**CERTIFICATE OF APPROPRIATENESS**

**Property:** Lot 6, Block 289, Houston Heights Subdivision, City of Houston, Harris County, Texas. The site includes a 1,370 square foot contributing residence situated on a 6,600 square foot (50 x 132) interior lot.

**Proposal:** Alteration – Addition – *Revision* The applicant was granted a COA on December 12, 2013 to construct a two-story addition.

**NORTH SIDE ELEVATION**

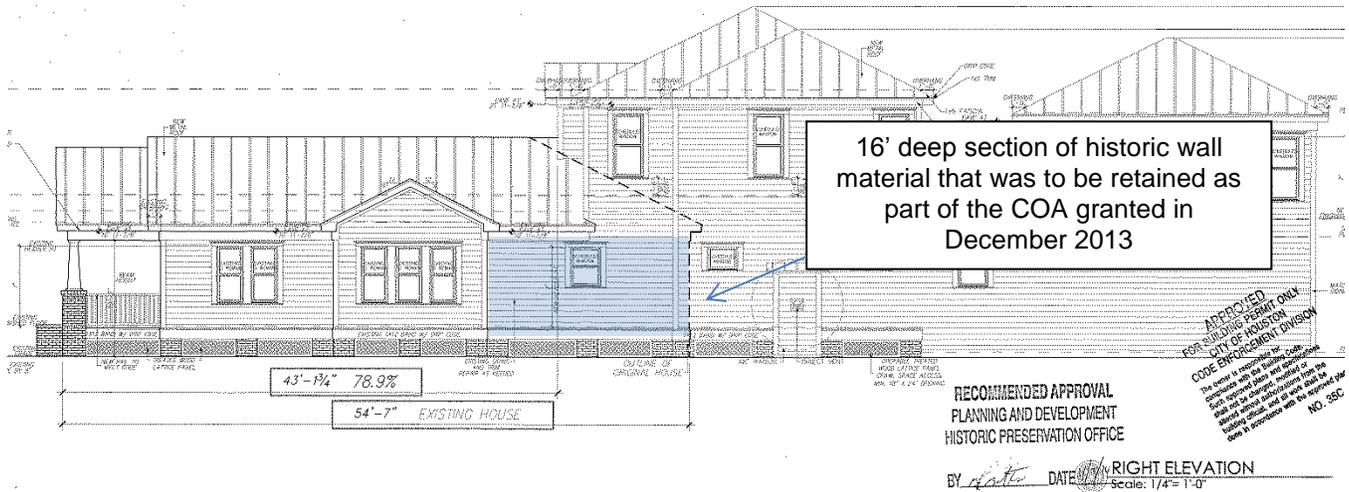
New windows

### FIRST FLOOR PLAN

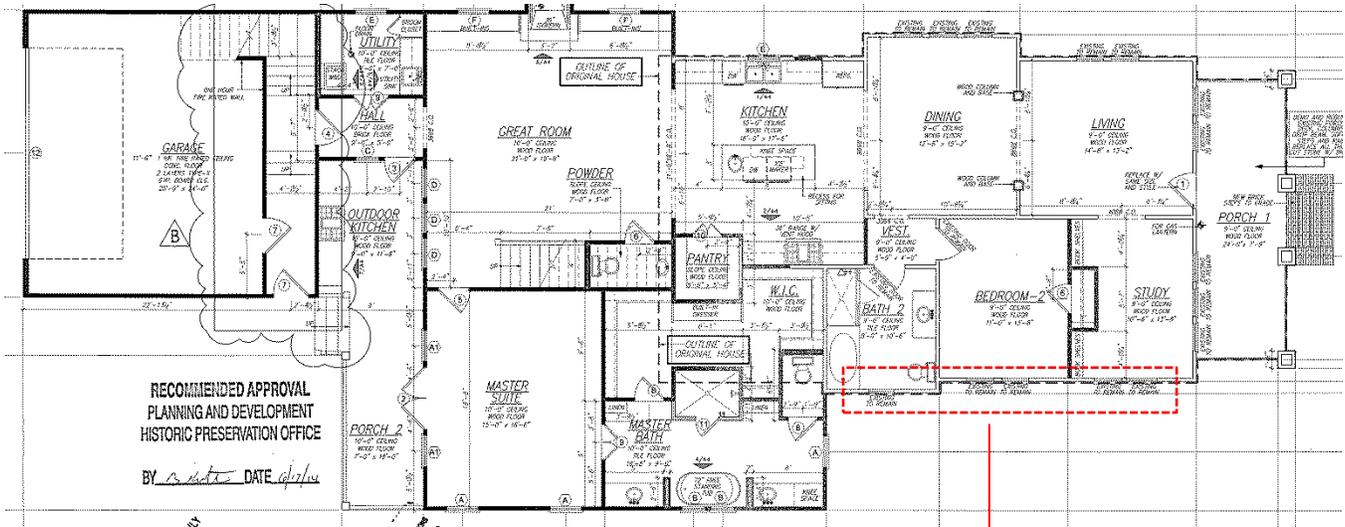
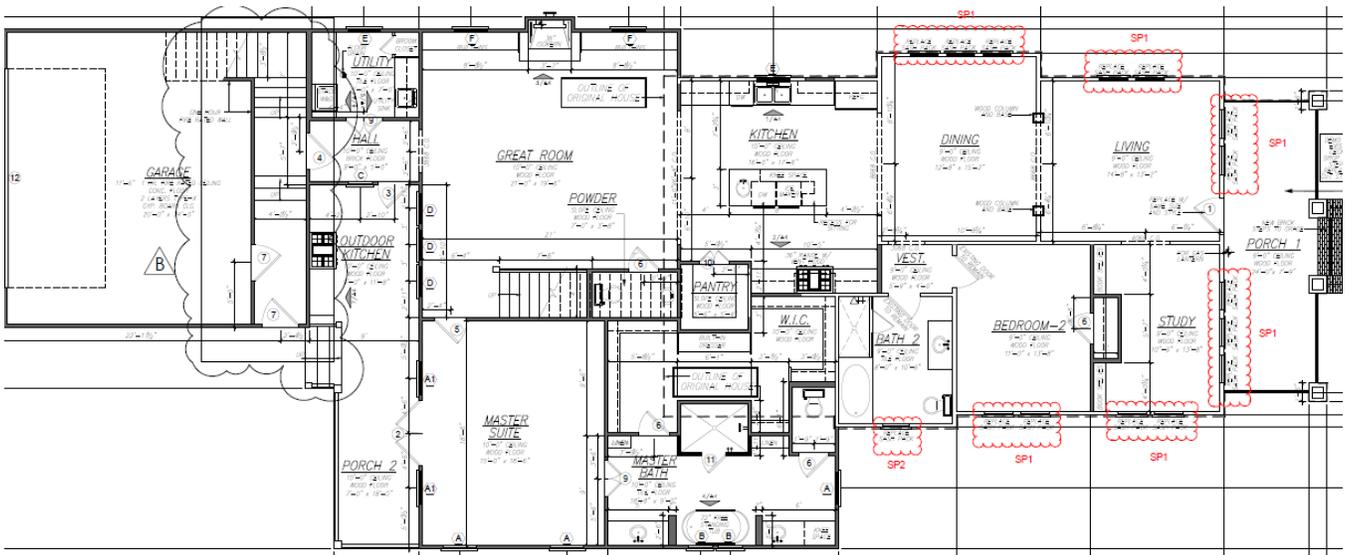
Existing to Remain notes by each  
 window

**DEMOLITION PLAN**

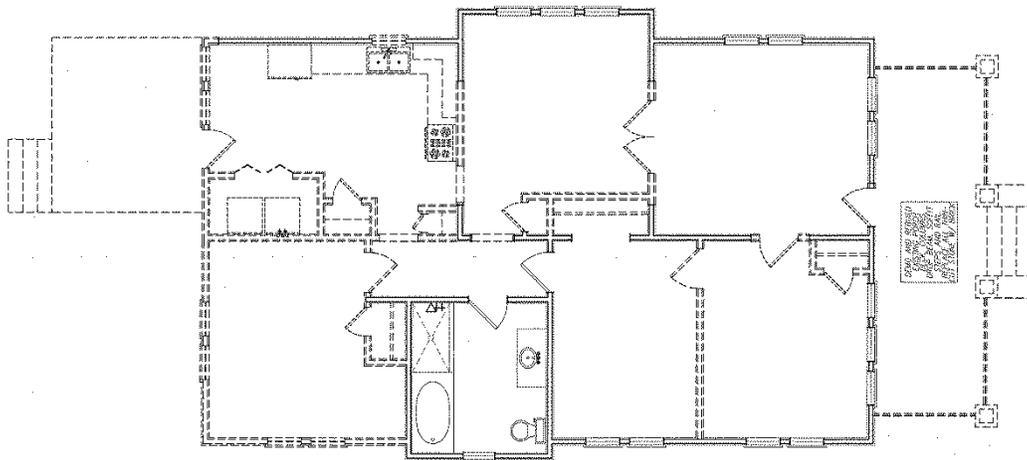
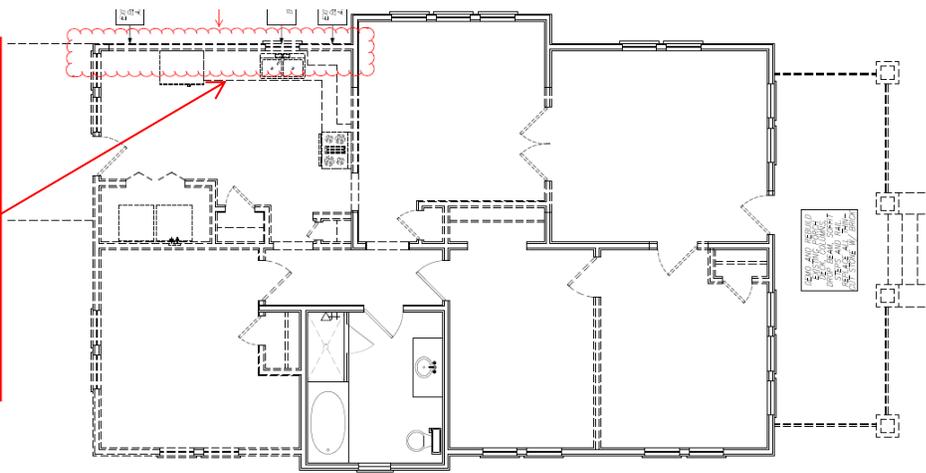
Existing wall at kitchen had to be re-framed due to the kitchen window being relocated 2' towards the back of the home. Additional support for window and second floor framing were needed for structural integrity.

**ROOF PLAN**

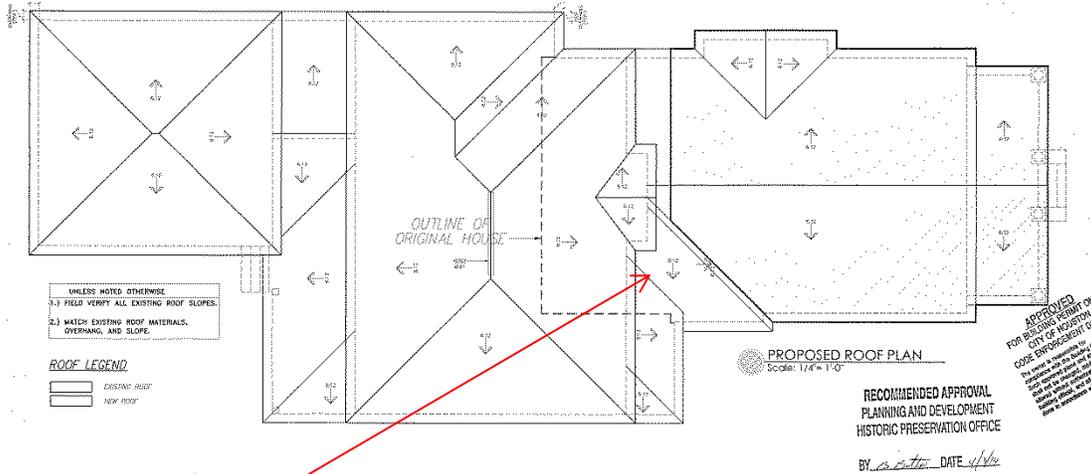
Approved hipped roof over south facing bump out

**Roof:** The existing south facing bump out originally featured a side facing gable. The applicant was approved to remove this gable and replace it with a hipped roof. The applicant now proposes to eliminate the hipped roof over the bump out and instead extend the existing roof structure to the rear to cover the bump out.

**PHOTOS OF WINDOW FRAMES**

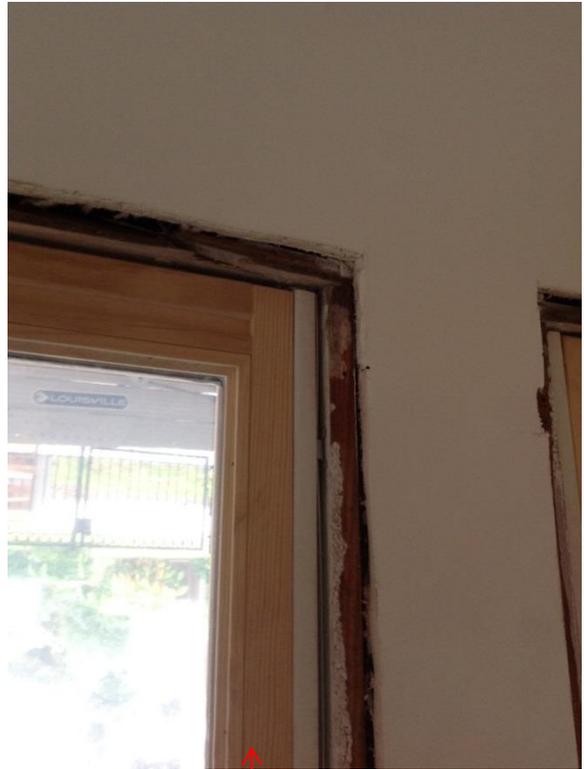
- (1) The proposed activity must retain and preserve the historical character of the property;  
*Historic wood sash windows are a character defining feature of this property and other historic properties within Houston Heights Historic District South. Replacing these historic windows with new windows represents a failure to preserve the historic character of the property.*

New window sashes installed  
within the existing window  
frames

**Windows/Doors:** Remove 15 original windows and replace with matching wood 1 over 1 interior mounted sash pack windows. These window sashes retain the existing window frames.

**Staff finds that the application would likely meet all applicable criteria if they replaced their new windows for historic salvaged wood sashes.**
